CHANGE ORDER NO. 2

PROJECT: East Water Reclamation Facility Phosphorus Removal Upgrades
OWNER: City of Crest Hill, Illinois
CONTRACT: 2-2021
CONTRACTOR: Williams Brothers Construction, Inc.

Description of Change

MCC-1 DEMOLITION AND ELEVATION

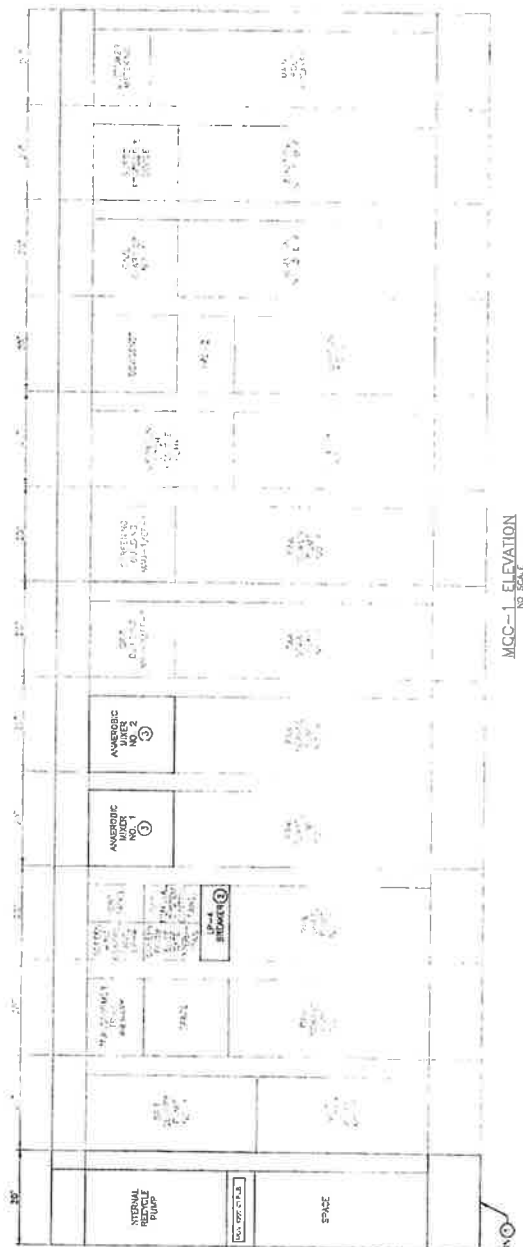
<p>Mike,</p> <p>See the RFI below from Elliott regarding MOV4000-01.</p> <p>Sheet 19 drawing 4000-E1.01 does NOT show any power for the actuator going in the 4000 flow meter vault. Sheet 36 drawing 99-E6.02 MCC-1 does NOT show any power being added for MOV-4000-01. This MOV is on-site and is a 3 phase 480 volt actuator. There is not a 480 volt panel in the screen building electric room. Can Strand advise to where this MOV is to be feed from and if a local disconnect is required and where it is to be located?</p> <p>Thanks, Bill</p>	
---	--

<p>SAI: Provide breaker in MCC-1 for MOV-4000-01 as specified in the revised MCC schedule attached. Local disconnect to be mounted to oxidation ditch concrete wall.</p> <p>Local disconnect, conduit, and conductors for MOV-4000-01 are not considered extra work for additional cost as MOV-4000-01 480V power symbol and local disconnect are shown on 4000-E1.01.</p>	
--	--
